ADDENDUM # 1

Pioneer Village Social Hall Renovation
#PV24-CF22-002
375 Taybin Road
Salem, OR 97304

April 29, 2024

PIC. #2

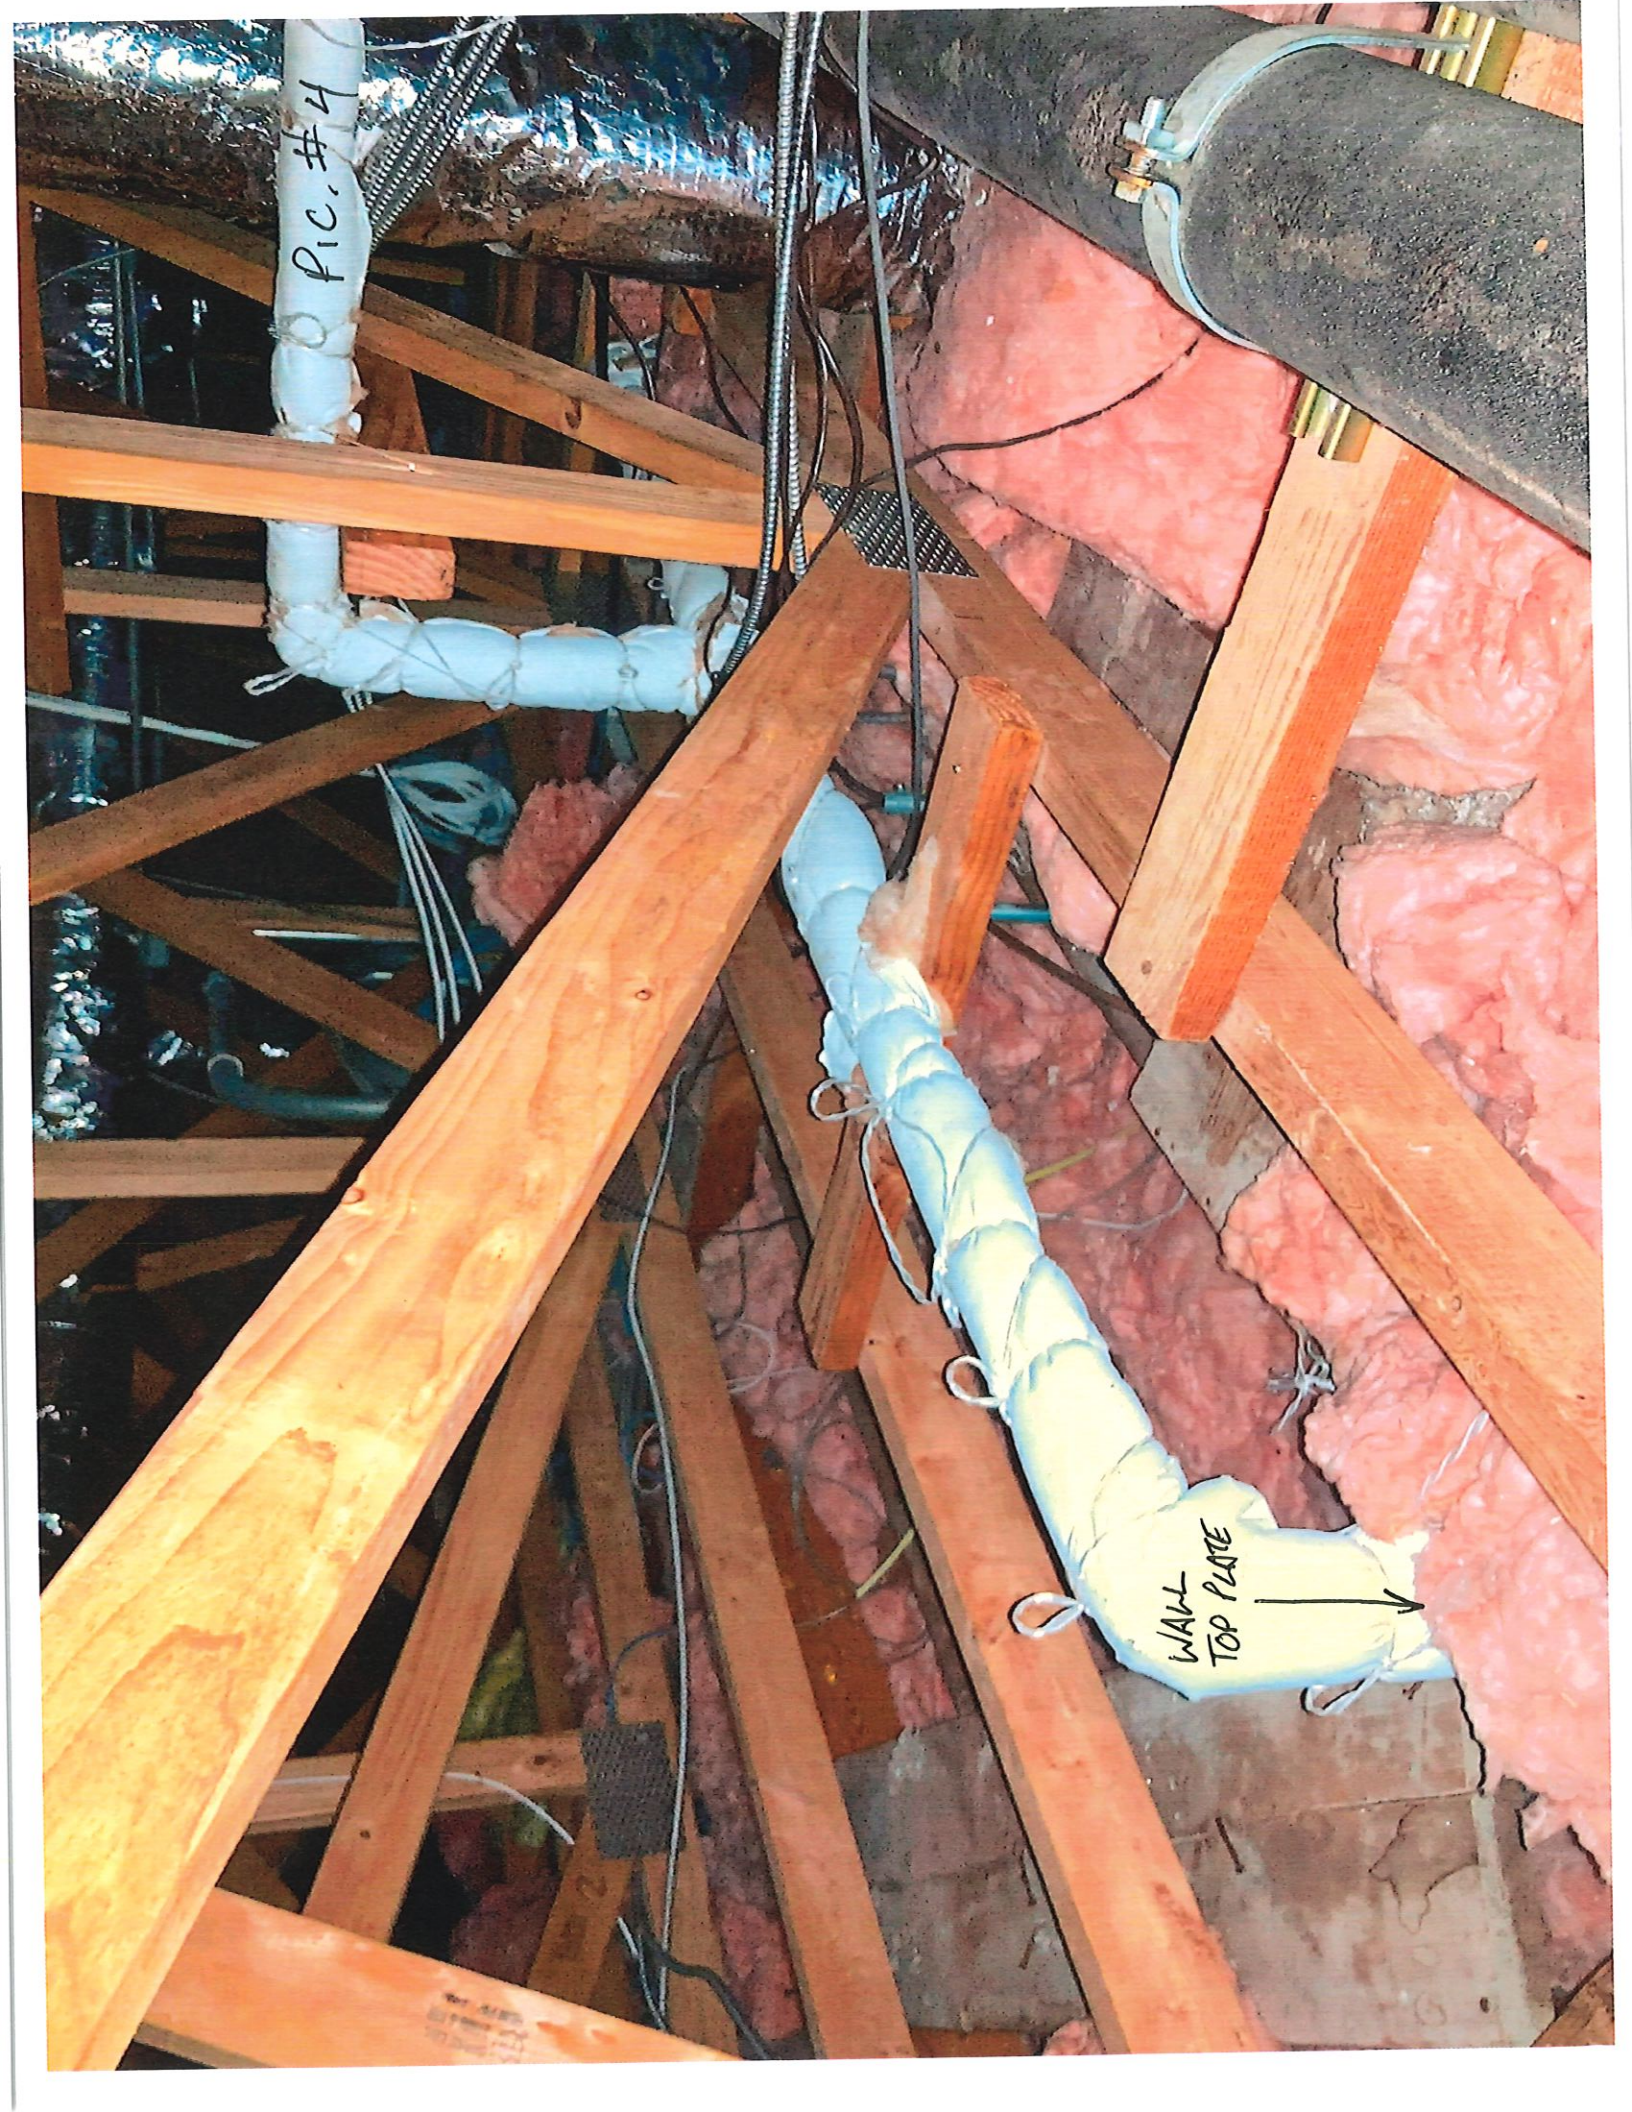
It has been found there is a 1 1/4" copper, main water supply coming up through sill plate of this wall and it runs up through the current wall cavity and into the attic space. There is currently a 1/2" copper lateral that feeds an exterior hose bib. This piping will need to be rerouted into the new wall by a plumber (with a shut off

valve like the current configuration) and the WVHA will allow the abandonment of the hose bib lateral in this new configuration. Costs associated with this work will need to be incorporated into the Bidder's proposal. (Existing wall access panel may be reused for valve access in new wall.) (Pictures of current pipe configuration attached (Pic's 1,2,3 & 4).)
